ADDENDUM #1

DATE: **September 16, 2022**

**EAST CAMPUS CHILLER PLANT – INSTALL WATER COOLED CHILLER
PROJECT NUMBER: CP212233**

M701

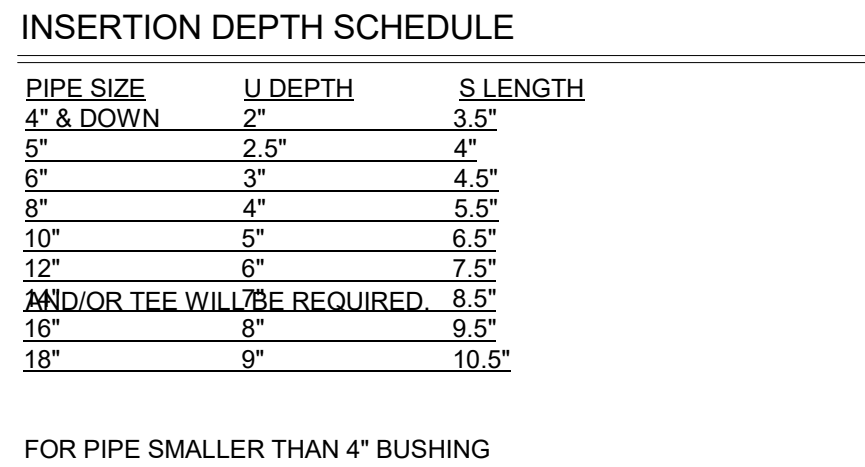
1. SHEET M701 – CONTROLS
 - a. Refer to reissued sheet for revisions.
 - i. MODIFY detail B Water Magnetic Flow Detail to reference existing flow meter is Siemens Magflo Mag 6000 with Mag 5100W.
2. SHEET E402
 - a. Detail 2 – ELECTRICAL CH-9 SECTION – **Revise** reference and note where transitioning from RMC to be **LIQUIDTIGHT FLEXIBLE METAL CONDUIT** in lieu of FLEXIBLE METAL CONDUIT.
